Access Compliance Report

Public Rights-of-Way

(Curb Ramps)

Intersection ID: 43172	Main Street: N_TRYON_ST	Cross Street: KEMP_ST	Location:	NE
ADA ID: 6DD5DB94EA89	Ramp Type: Perp	Initial Pass/Fail: Fail	Overall Compliance: No	Severity Score: 10
Codes/Mitigation Info/Possible Solution		Field Measurements/Component Compliance

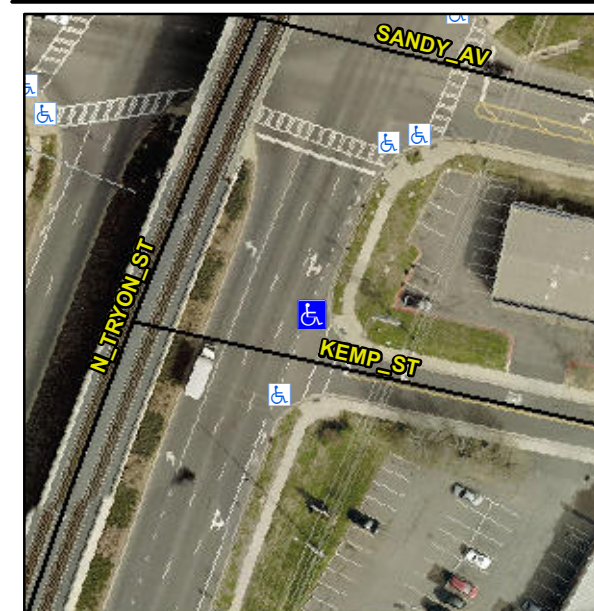
Not Found, R304.5.1, R304.5.3

Compliance	Description	Data	Compliance	Description	Data
N/A	Ramp Length (in)	60.0	Yes	Ramp Slope (%)	6.6
No	Ramp Width (in)	46.0	No	Ramp XSlope (%)	2.6
N/A	Flare Type LT	N/A	N/A	Flare Type RT	N/A
N/A	Flare Slope LT (%)	N/A	N/A	Flare Slope RT (%)	N/A
N/A	Flare Traversable LT?	N/A	N/A	Flare Traversable RT?	N/A
N/A	Landing Length (in)	N/A	N/A	DWS Provided?	N/A
N/A	Landing Width (in)	N/A	N/A	DWS Contrast?	N/A
N/A	Landing Slope (%)	N/A	N/A	DWS Length (in)	N/A
N/A	Landing X Slope (%)	N/A	N/A	DWS Full Width?	N/A
N/A	Landing Curb? (Y/N)	N/A	N/A	DWS Offset (in)	N/A
N/A	Shared Landing?	N/A			
N/A	Gutter Ponding?	N/A	N/A	Gutter Slope (%)	N/A
N/A	Gutter Lip Ht (in)	1.0	N/A	Gutter X Slope (%)	N/A
N/A	Painted X Walk1?	Yes	N/A	Painted X Walk2?	N/A
	X Walk 1 Direction	To SW		X Walk 2 Direction	N/A
N/A	X Walk 1 Width (in)	118.0	N/A	X Walk 2 Width (in)	N/A
	X Walk 1 Slope (%)	1.0		X Walk 2 Slope (%)	N/A
	X Walk 1 X Slope (%)	4.9		X Walk 2 X Slope (%)	N/A

Remove & Replace Entire Ramp.
